Project	IEEE 802.16 Broadband Wireless Access Working Group < http://ieee802.org/16 >	
Title	State machine for RS Network Entry	
Date Submitted	2008-03-13	
Source(s)	Kanchei (Ken) Loa, Yi-Hsueh Tsai, Yung-Ting Lee, Hua-Chiang Yin, Shiann-Tsong Sheu, Youn-Tai Lee	Voice: +886-2-66000100 Fax: +886-2-66061007 loa@iii.org.tw
	Institute for Information Industry 7F, No. 133, Sec. 4, Minsheng E. Rd., Taipei City 105, Taiwan	
Re:	IEEE 802.16-08/007: "IEEE 802.16 Working Group Letter Ballot Recirc #28b: Announcement"	
Abstract	This contribution proposes state machine for RS network entry	
Purpose	Text proposal for 802.16j Draft Document.	
Notice	<i>This document does not represent the agreed views of the IEEE 802.16 Working Group or any of its subgroups. It represents only the views of the participants listed in the "Source(s)" field above. It is offered as a basis for discussion. It is not binding on the contributor(s), who reserve(s) the right to add, amend or withdraw material contained herein.</i>

State machine for RS Network Entry

Figure xxx—Network entry state machine REG-REQ at a MR-BS

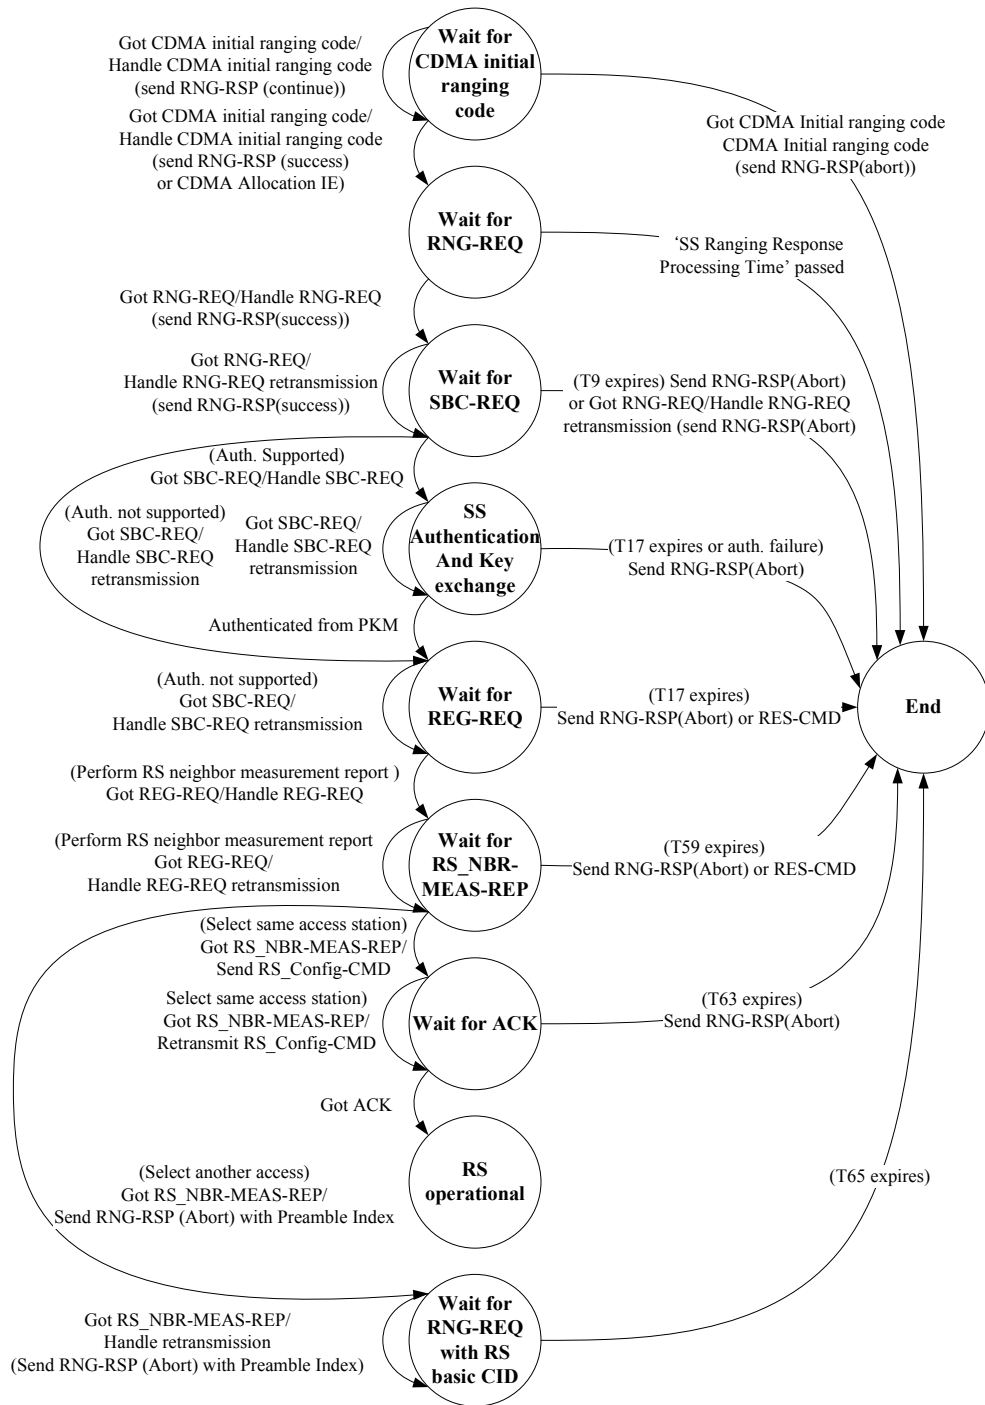
In P80216Rev2/D3, there are two network entry state machines defined for the BS side and the SS side respectively (Figure 85 and Figure 86). However, in P802.16j/D3, there is no “Network entry state machine” to describe error path for the RS and the MR-BS. We proposed to add the “Network entry state machine” for the transparent RS, the non-transparent RS and the MR-BS.

[Insert the following subclause as indicated:]

Figure xxx describes the network entry process on the MR-BS side. Figure yyy describe the network entry process on the RS side.
